Technical Bulletin Bracket Transition A-081-G to MBB-081

MBB-081

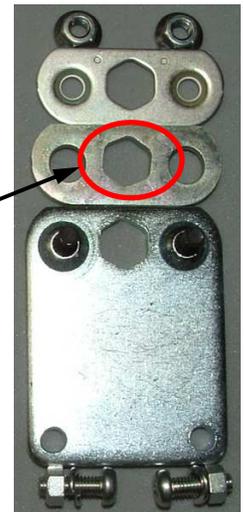
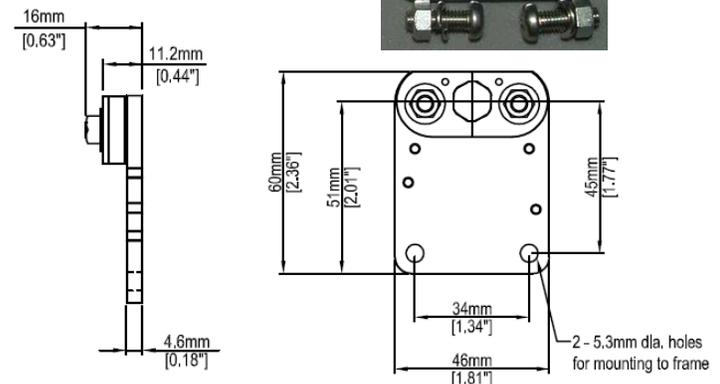
The A-081-G bracket has been replaced by the MBB-081. The A-081-G will no longer be available to purchase. The MBB-081 will be available for both new applications and replacements of the A-081-G.

The MBB-081 is a universal mounting bracket that will become the standard for all DC rollers that have a plain 7/16" Hex shaft.

- The shaft hole of the middle mounting plate is rotated a few degrees which grips the shaft securely once the top plate and nuts are tightened to the correct torque.

Rotated shaft hole
